Technical Note

Project: Yarnton, Oxfordshire

Subject: Response to Yarnton Flood defence Group Comments

Client:	Merton College	Version:	A
Project No:	06058	Author:	Amy Evans
Date:	30th June 2022	Approved:	Alison Caldwell

Surface Water Drainage
CCTV Survey

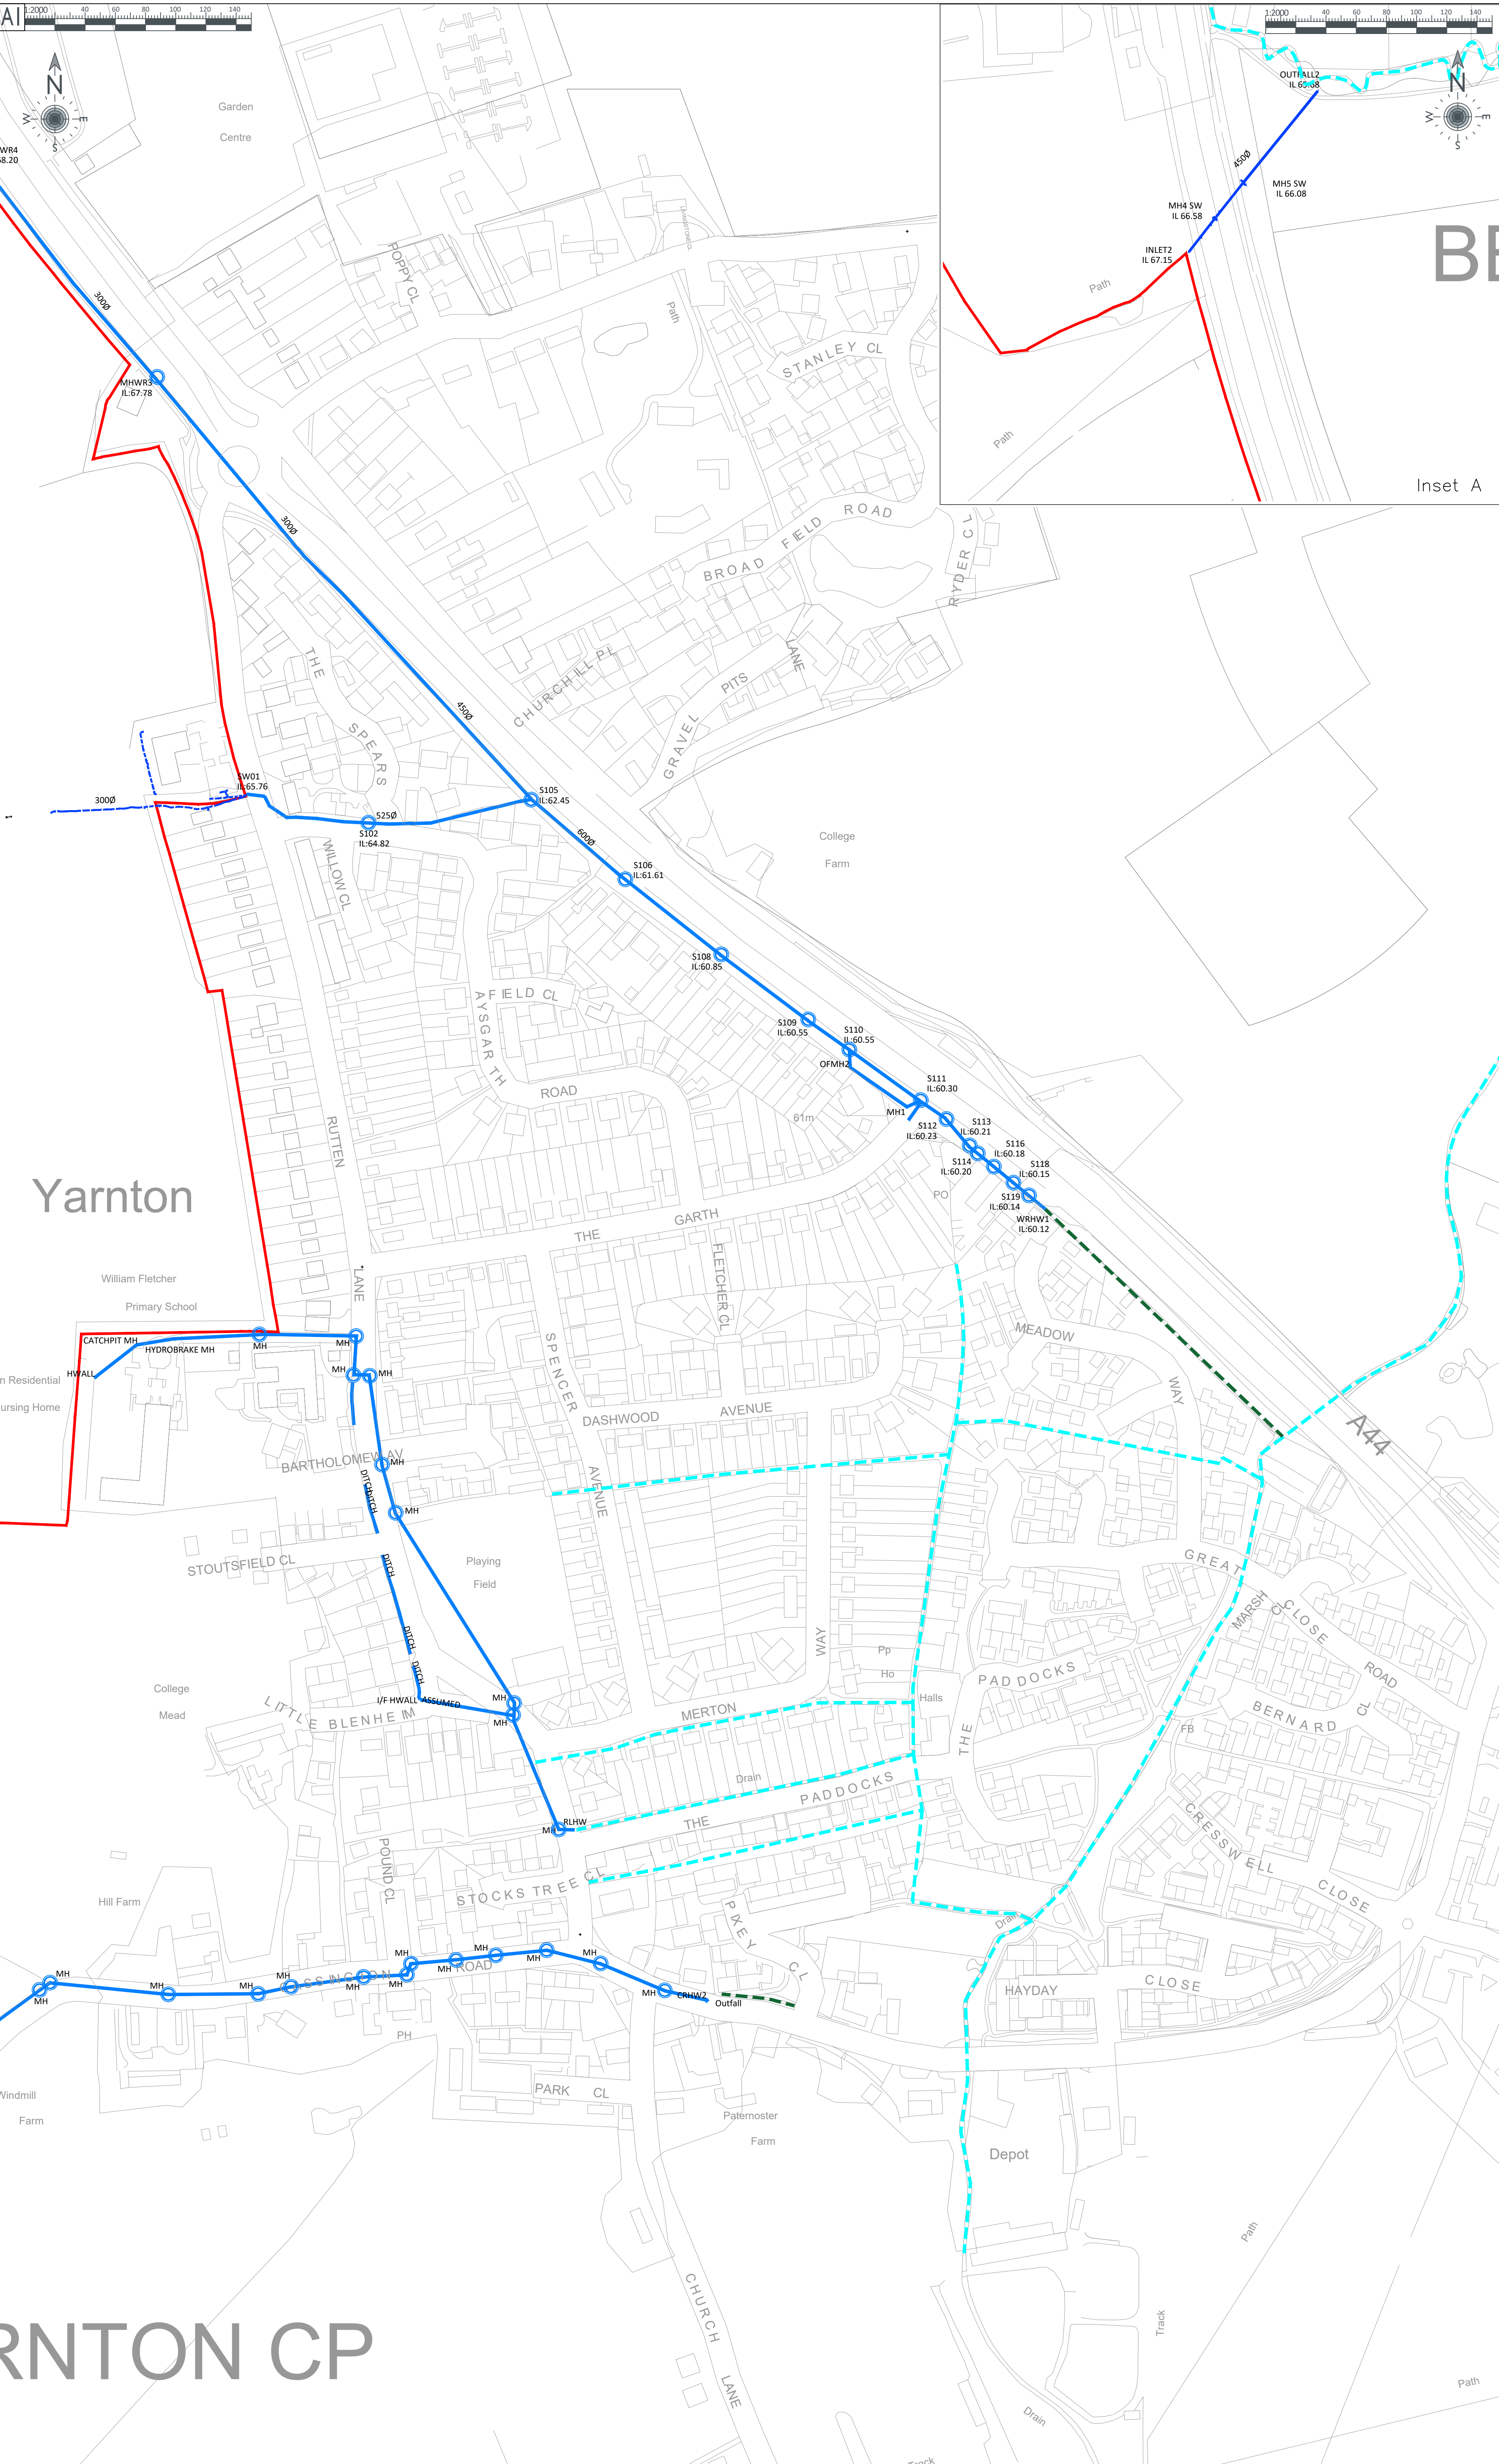
2.1.10 *"We were glad to hear that you have had the surface water drain between the surgery and its outfall on the A44 camera surveyed and from the results you have seen that it is generally in a very good condition with the exception of some minor root infestation. We would appreciate seeing the results at some point soon."*

2.1.11 The CCTV survey will be provided within Appendix C of the updated FRA (2022). In the interim, a summary map showing the outcome from the CCTV survey and the respective connection of the outfalls from the Site into the Main River connections has been provided within Appendix A.
